SERVICE 		5 X 88.112-26
---	--	------------------

MODEL **244 RX**

NEW AIR INLET

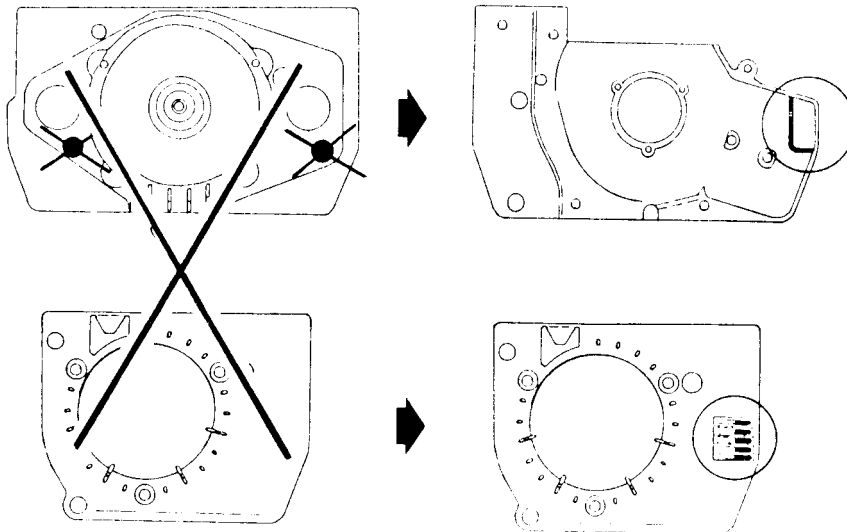
The air inlet is moved from the clutch side to the flywheel side in order to get a cleaner intake air and with that also improved air filter function. The intake air is taken via an air inlet in the starter housing on the flywheel side of the crankcase.

At the same time, the earlier air inlets in the clutch side of the crankcase are removed.

The change is introduced from serial number 7410500,

When mounting a new starter housing with this new air inlet on older saws manufactured before serial number 5090960, the clamp ref. no. 502 05 62-01 must be cut 8 mm (5/16"), according to the illustration.
